SH-BCU-66

CADDY NO. 1398 ITEM NO. 12

JOB: UNIVERSITY HOSPITAL OF CLEVELAND
LOC: CLEVELAND, OHIO
CUST:
CUST#:

DWG# D-1-1398 SHT 1 OF 7

SH-BCU-48

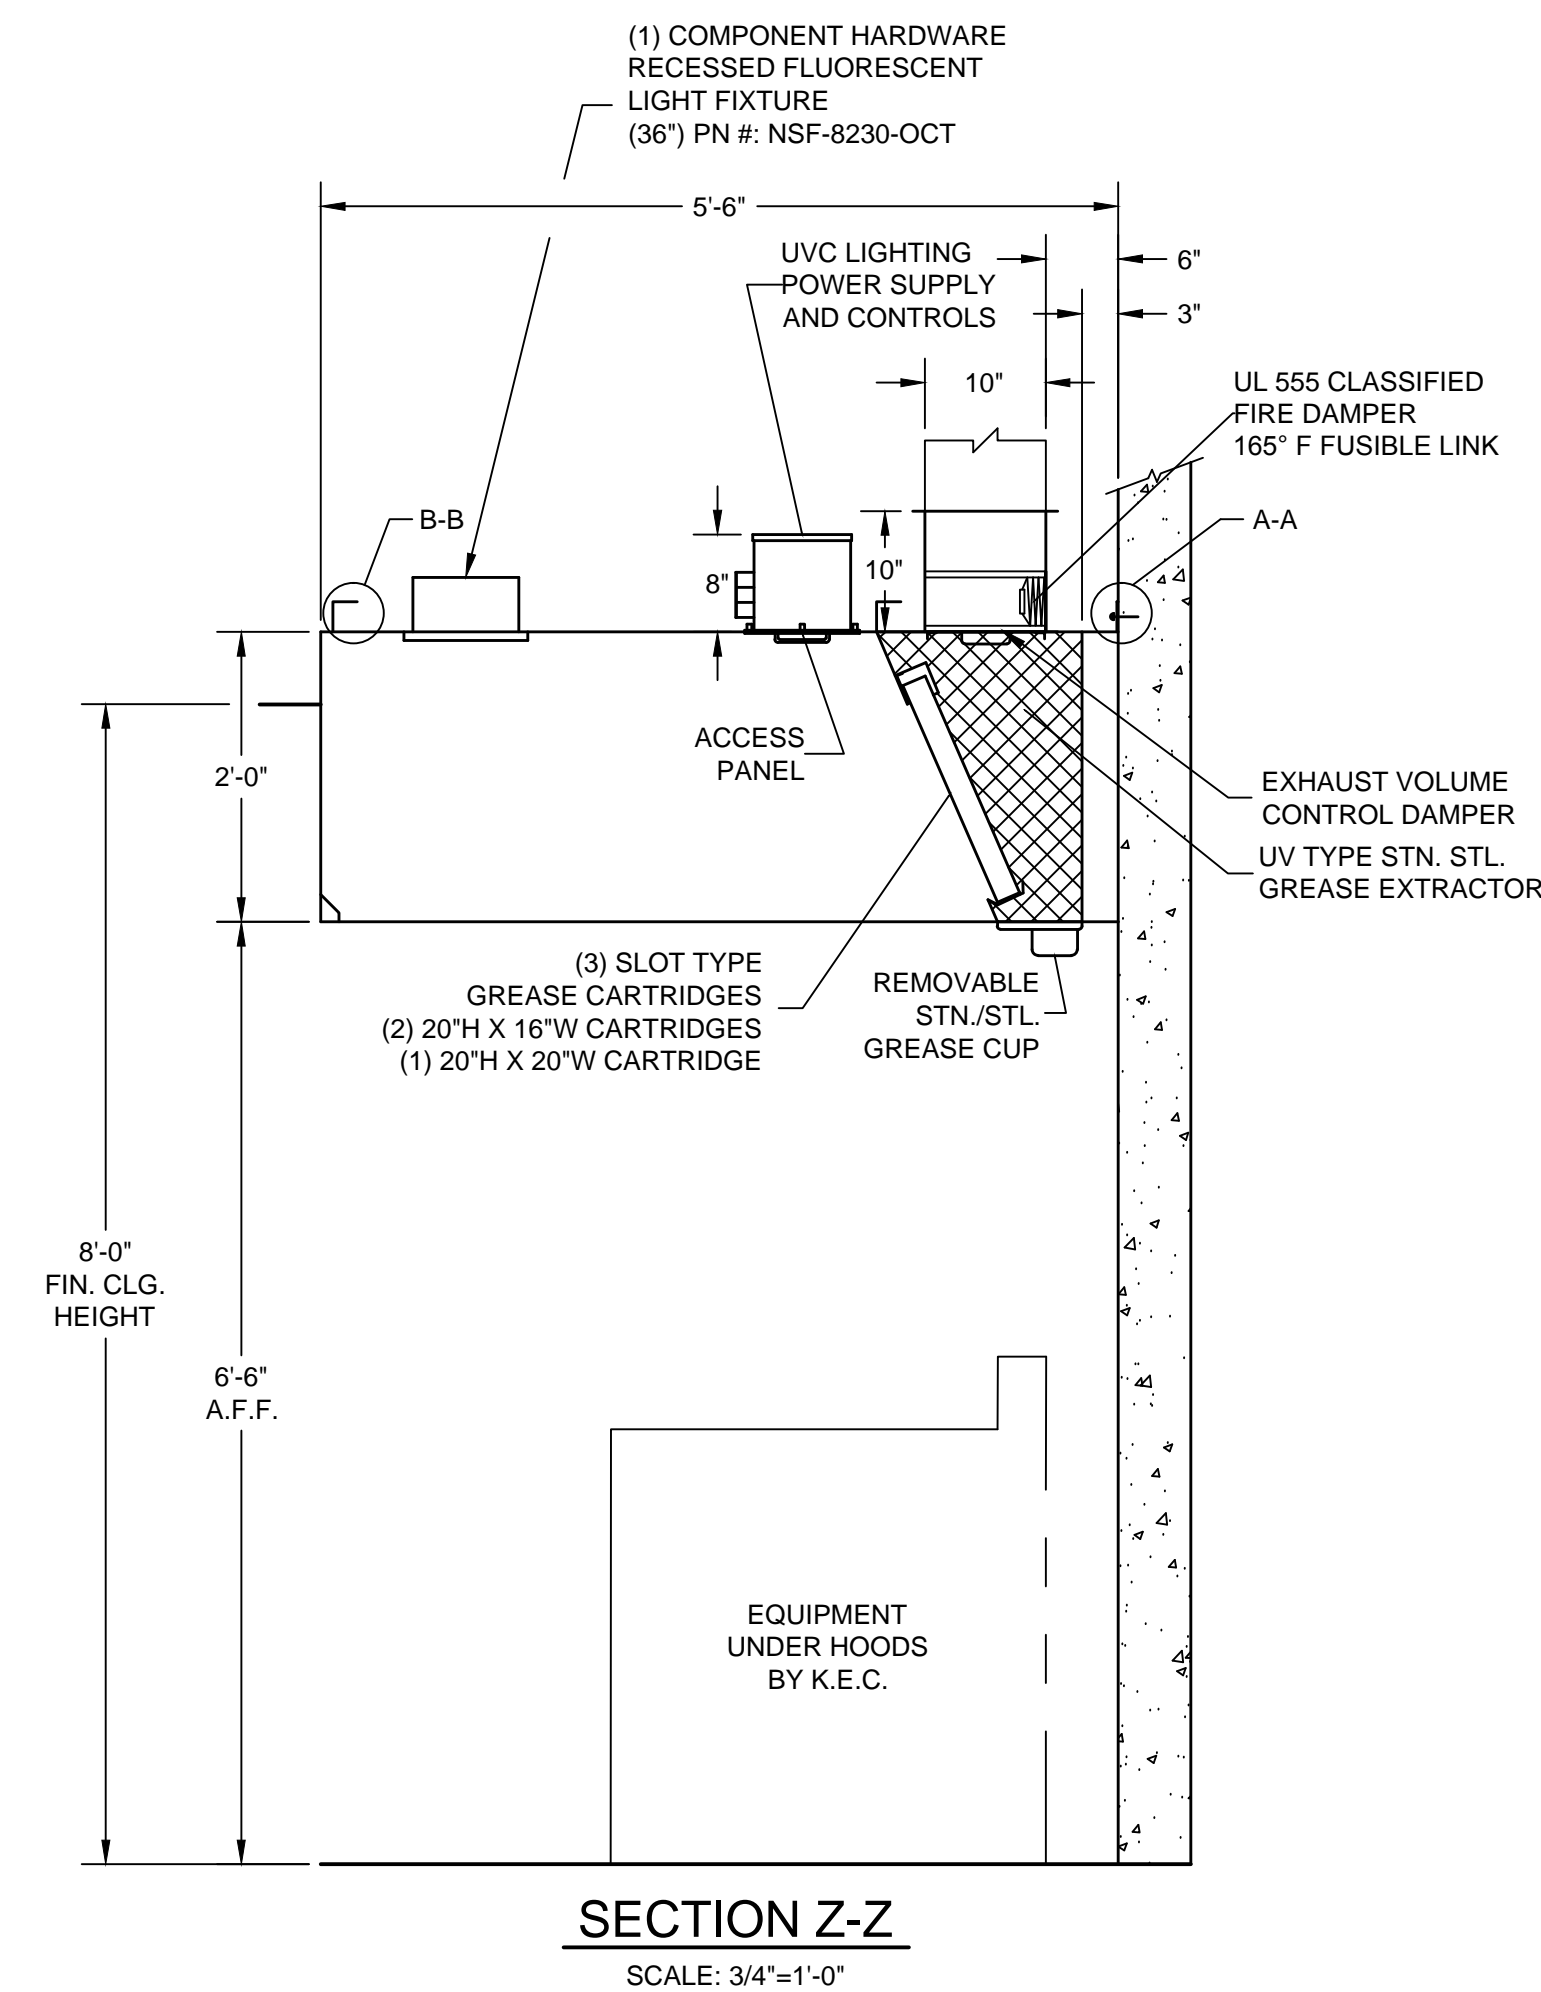
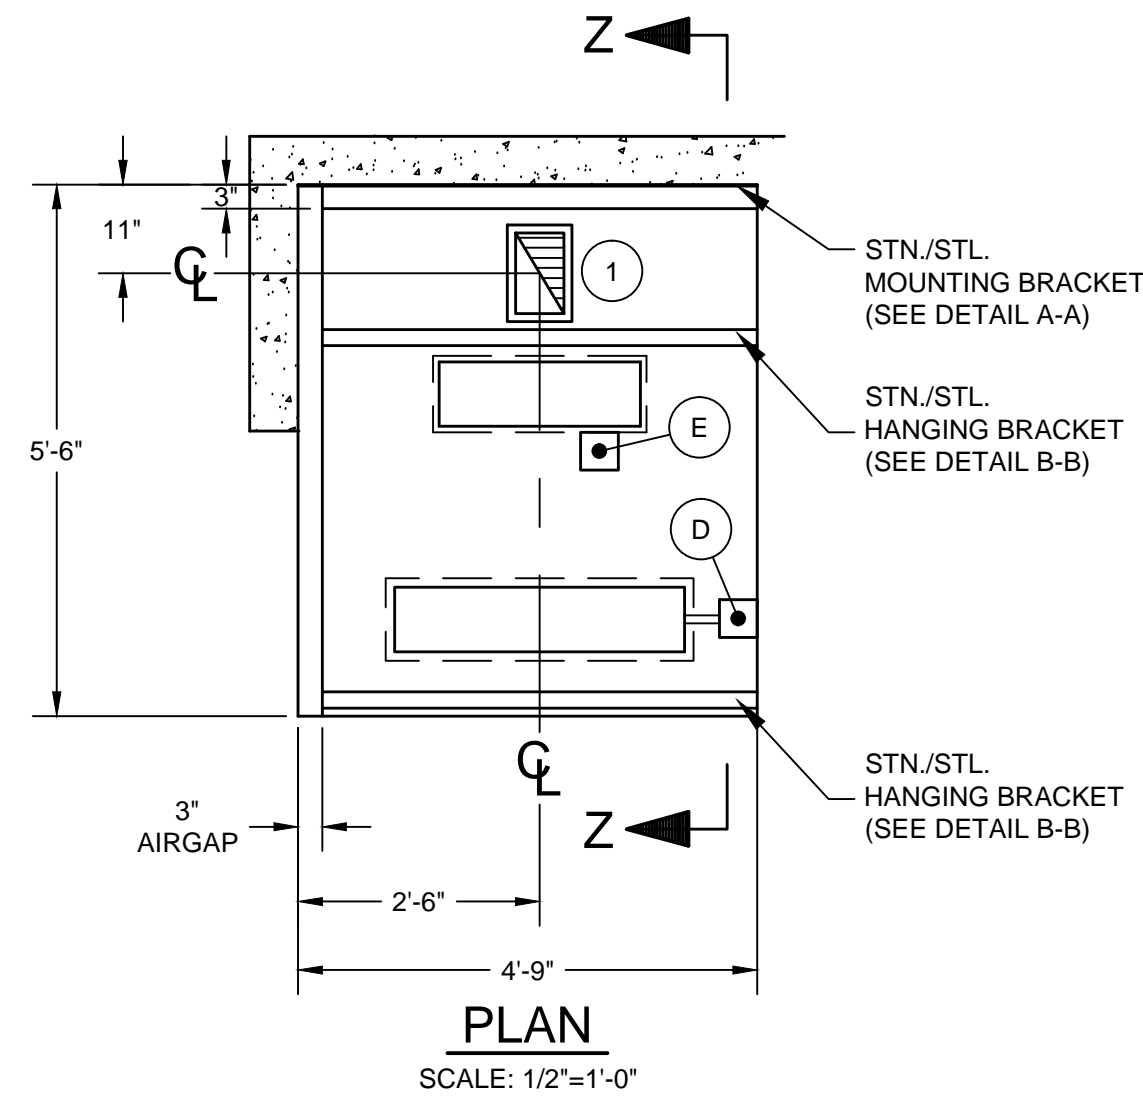
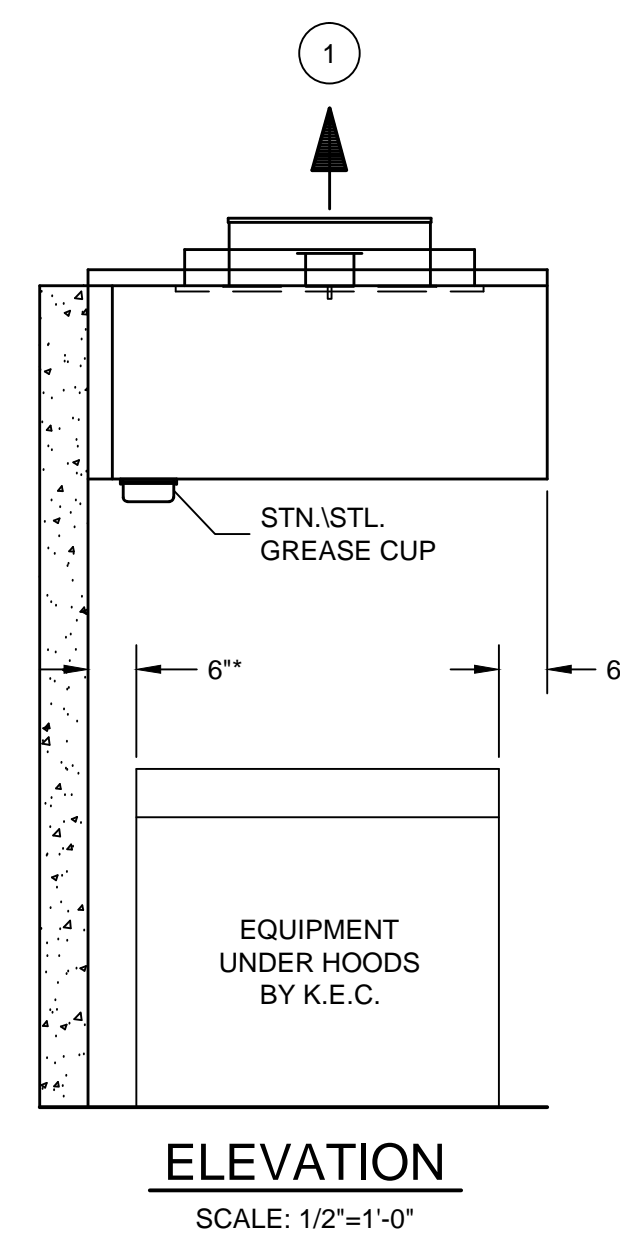
REVISIONS			
REV	DATE	BY	REMARKS
A	9-24-04	SWL	REVISED PER PHONE CONVERSATION WITH PAUL BERINSKY OF H-MAK ON 09/24/04. REVISED THE VENTILATOR'S HEIGHT FROM 30" TO 24". REVISED THE FINISHED CEILING HEIGHT FROM 9'-0" TO 8'-6".
B	9-28-04	SWL	FABRICATED PER APPROVED DRAWING FROM PAUL BERINSKY OF H-MAK ON 09/27/04. REVISED FINISHED CEILING HEIGHT FROM 8'-6" TO 8'-0".
C	10-8-04	SWL	NO CHANGES TO THIS SHEET
D	11-29-04	SWL	NO CHANGES TO THIS SHEET

FIELD WIRING REQUIREMENTS FOR THE
UVC HOOD EQUIPMENT

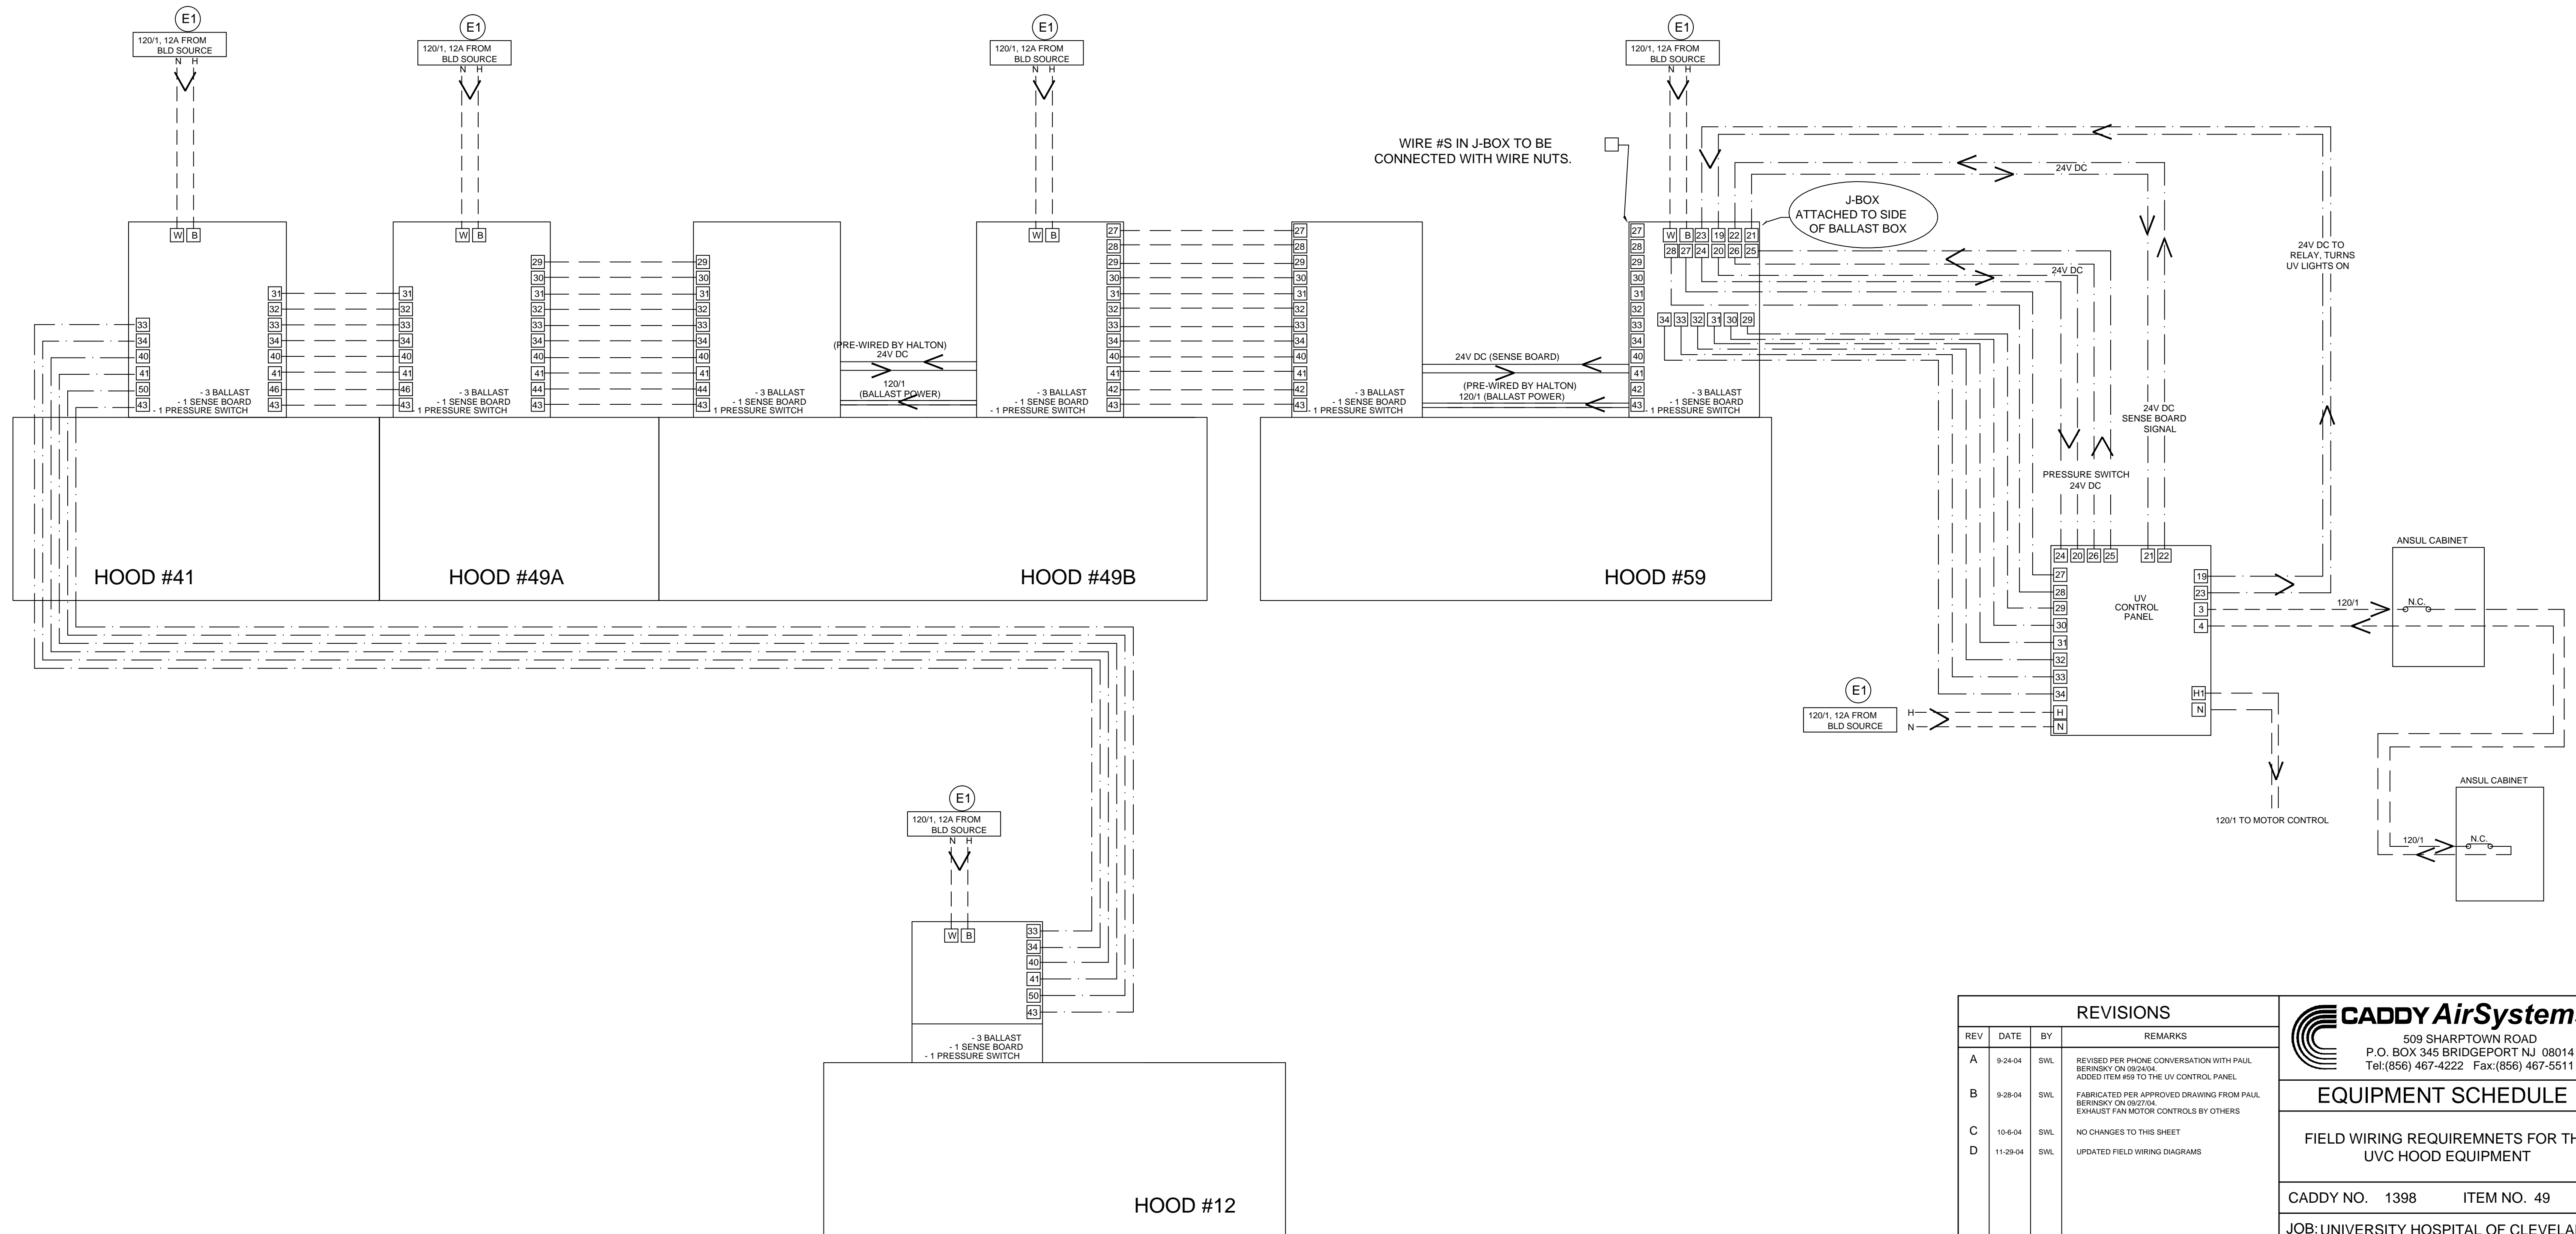
REVISIONS			
REV	DATE	BY	REMARKS
A	9-24-04	SWL	REVISED PER PHONE CONVERSATION WITH PAUL BERINSKY ON 09/24/04 ADDED ITEM #59 TO THE UV CONTROL PANEL
B	9-28-04	SWL	FABRICATED PER APPROVED DRAWING FROM PAUL BERINSKY ON 09/27/04 EXHAUST FAN MOTOR CONTROLS BY OTHERS
C	10-6-04	SWL	NO CHANGES TO THIS SHEET
D	11-29-04	SWL	UPDATED FIELD WIRING DIAGRAMS
